DOCUMENT 009113 – ADDENDA NUMBER 03

- A. Project Name: St Gregory the Great Dorm Addition.
- B. Owner: St Gregory the Great Seminary.
- C. Architect: Clark Architects Collaborative 3.
- D. Architect Project Number: 14021.
- E. Date of Addendum: 05/19/2016.

AAD-01
Addendum 03

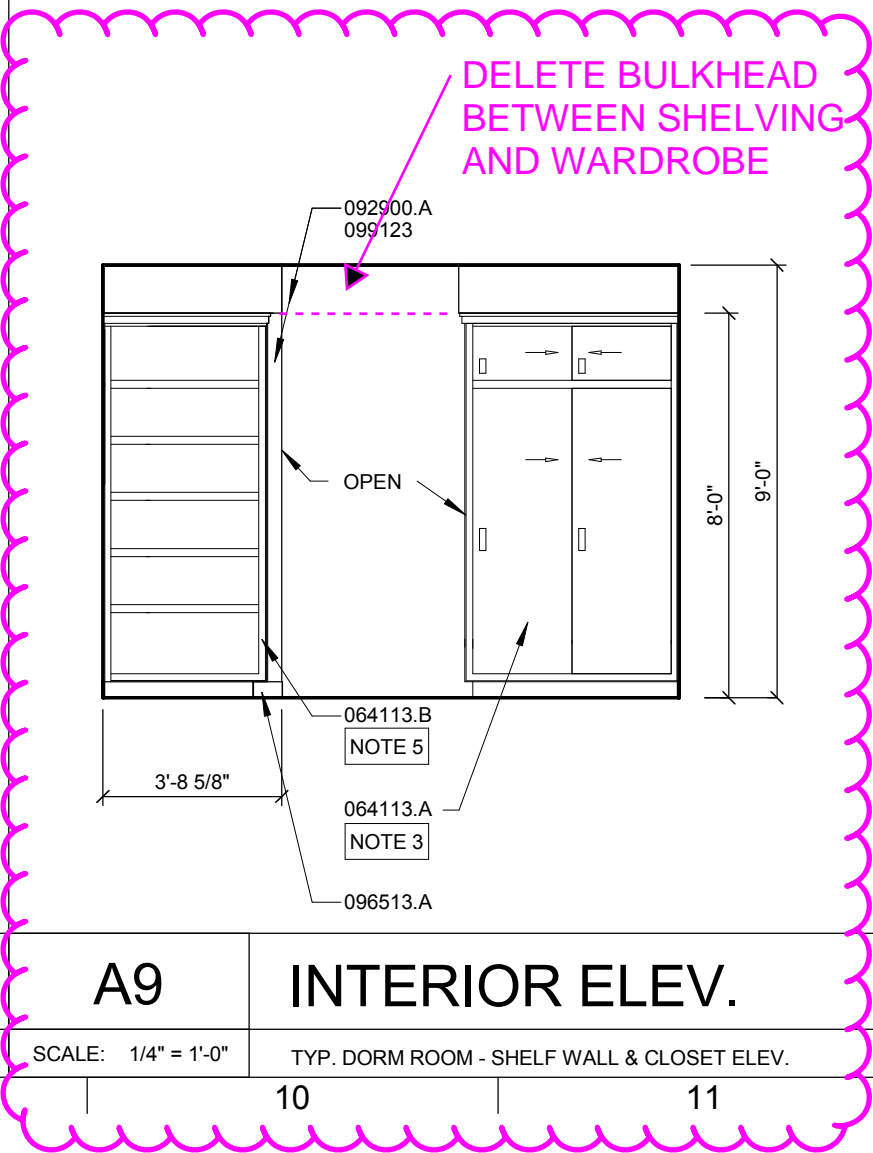
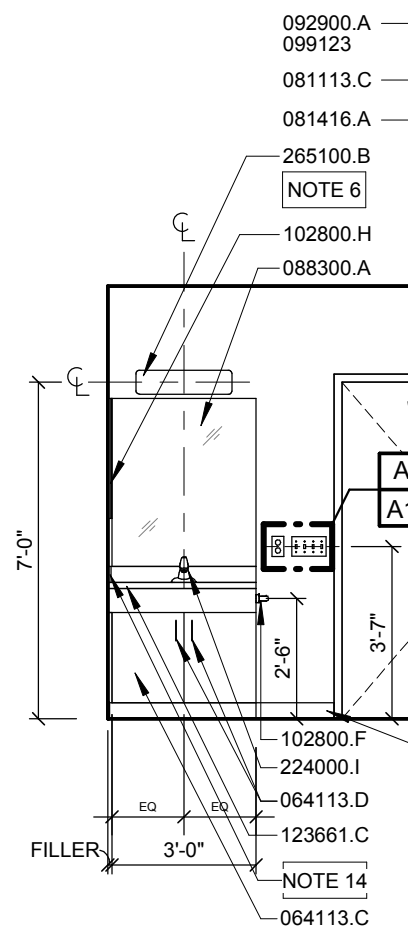
- D. Sheet A11 – Dorm Addition – Enlarged Plans and Interior Elevations (not reissued).
 - 1. Refer to Drawing A9: There is to be no bulkhead between the shelving unit and the wardrobe. See AAD-01.

**AAD-C1.2
Addendum 03**

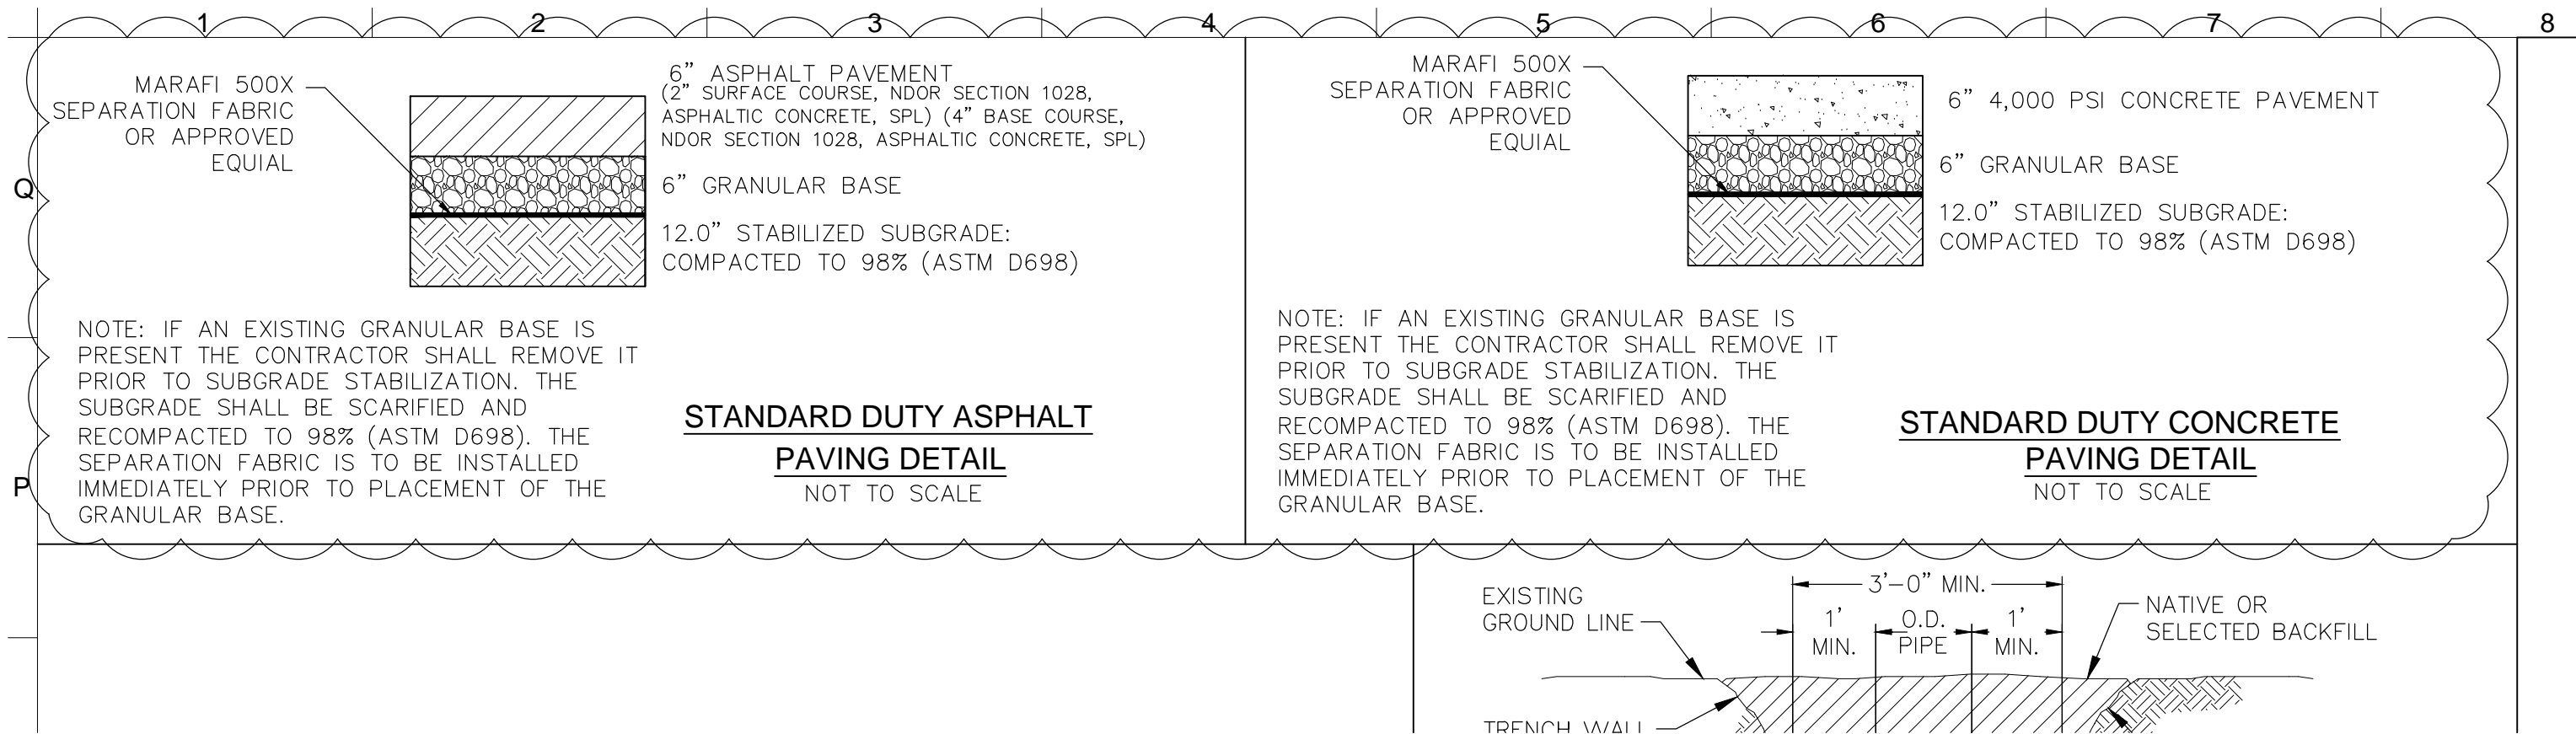
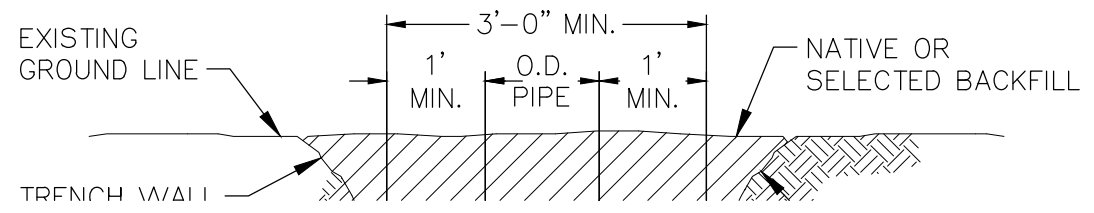
- A. Sheet C103 – Detail Sheet (not reissued).
1. New details included in this addendum are to be added to this sheet. AAD-C1.2 and AAD-C1.3 are included with this addendum and show concrete and asphalt details and concrete pavement joint details (respectively).

| DRAWING TITLE: PAVING REMOVALS PLAN | |

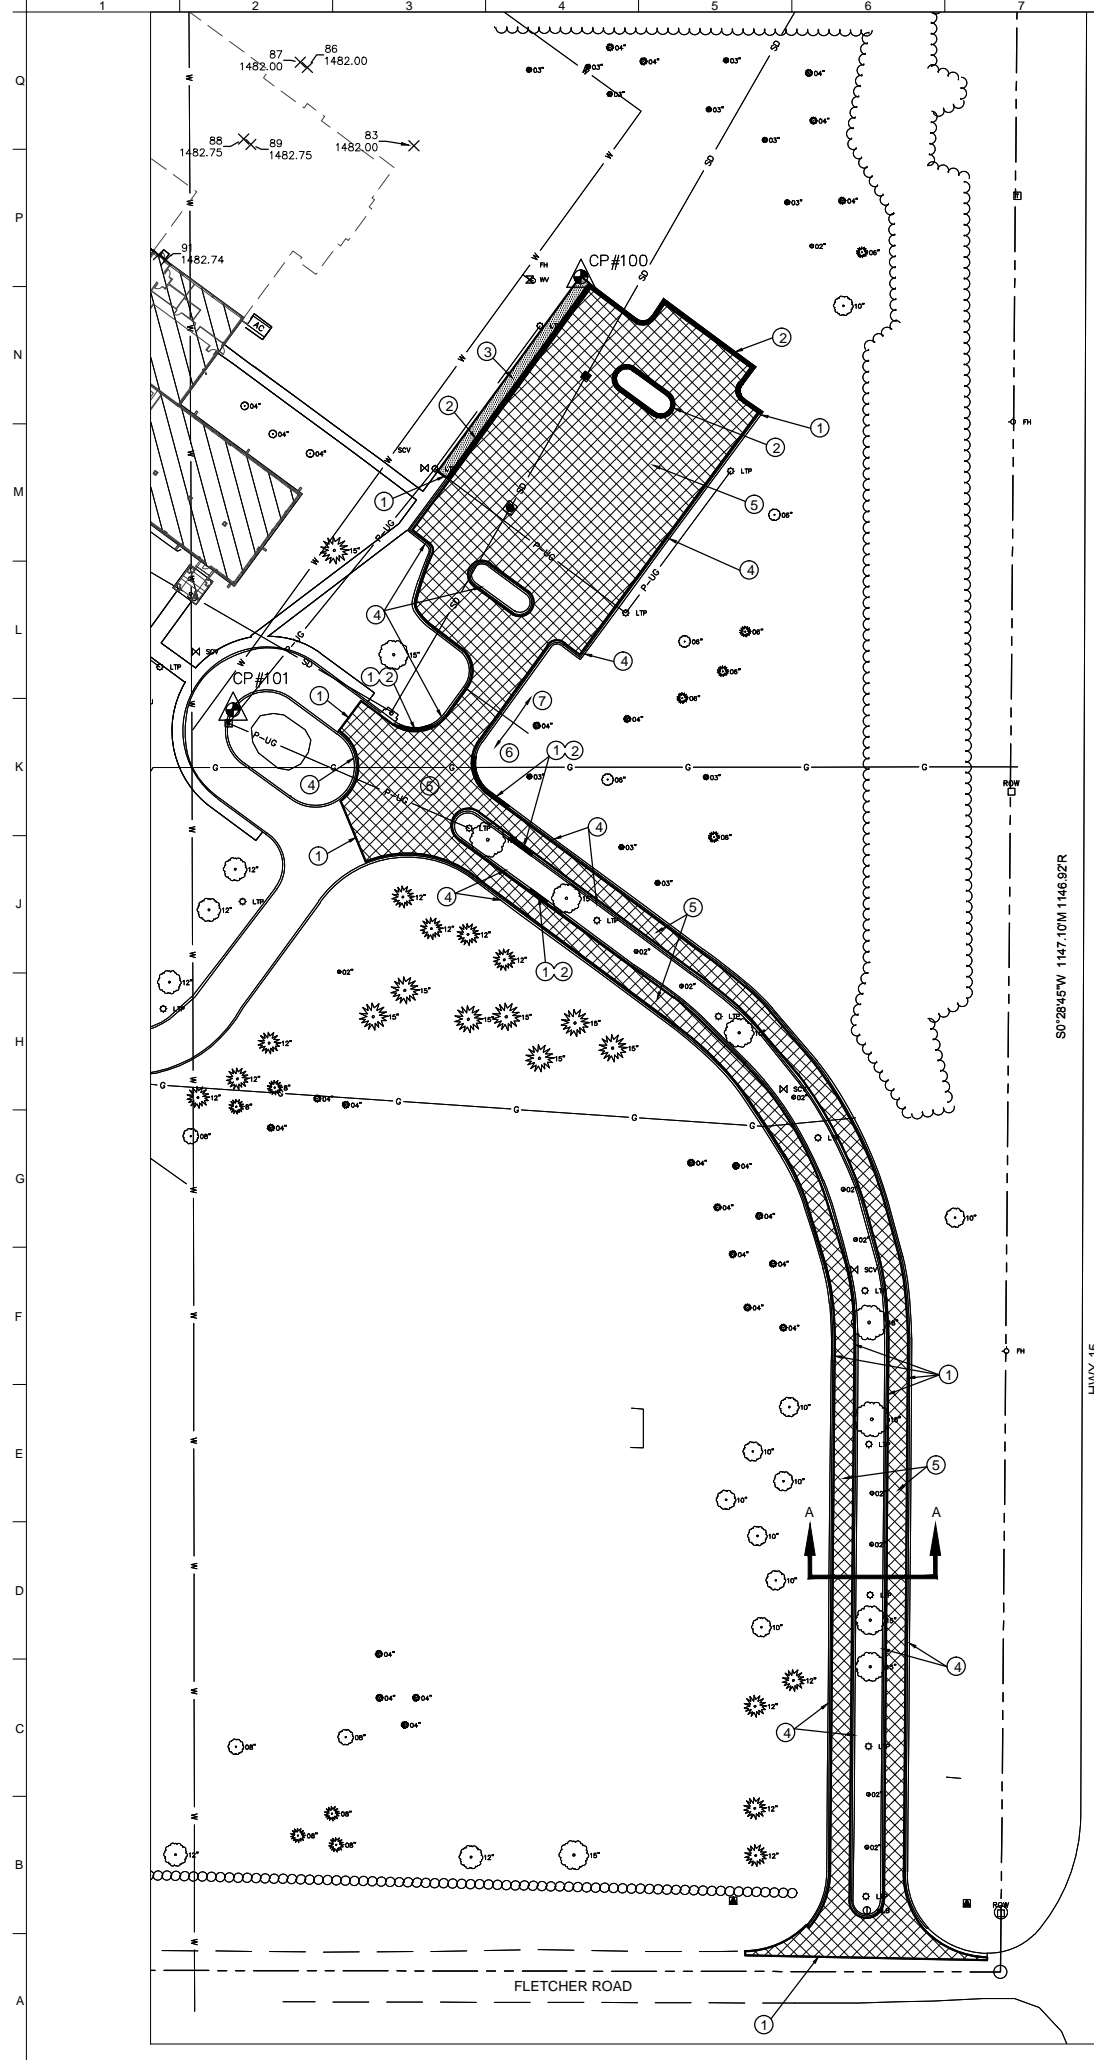
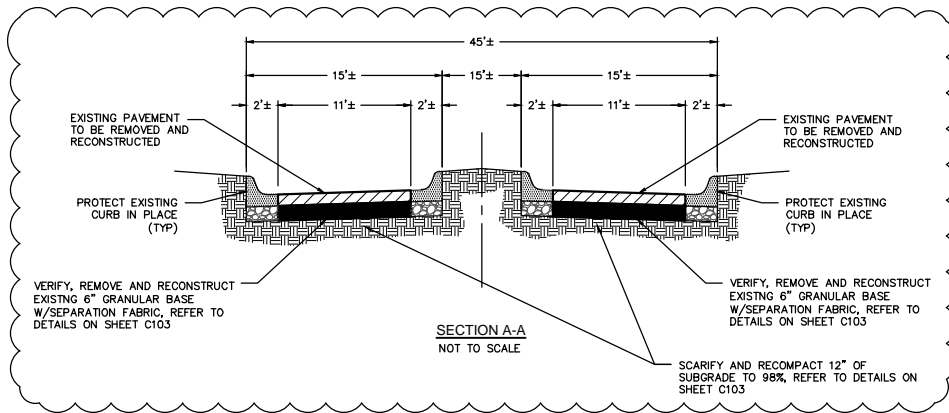
- B. Sheet C401 – Paving Removals Plan (reissued).
 - 1. Refer to Section AA and to the Paving Legend. The paving Section AA has been revised and the Paving Legend has been revised to include concrete pavement as an alternate.
